Access Compliance Report

Public Rights-of-Way

(Pedestrian Signals)

Intersection ID: N/A	Main Street:	Cross Street: N/A	Location: N/A
ADA ID: F47CC25E82E4	Signal Type: One Push Button-Non APS	Overall Compliance: No	Severity Score: BTN 1: N/A BTN 2: N/A No BTN: N/A
Codes/Mitigation Info/Possible Solution		Field Measurements/Component Compliance

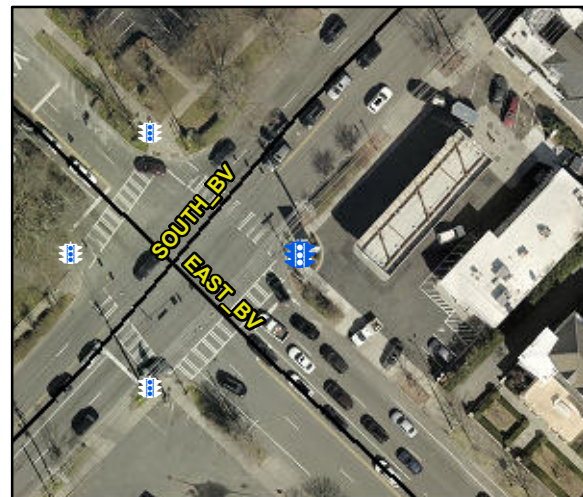
PROW/ADA: TMUTCD 4e.08, R406.2

Possible Solutions: Replace Signal Push Button With APS Button on New Post. Remove & Relocate Sign.
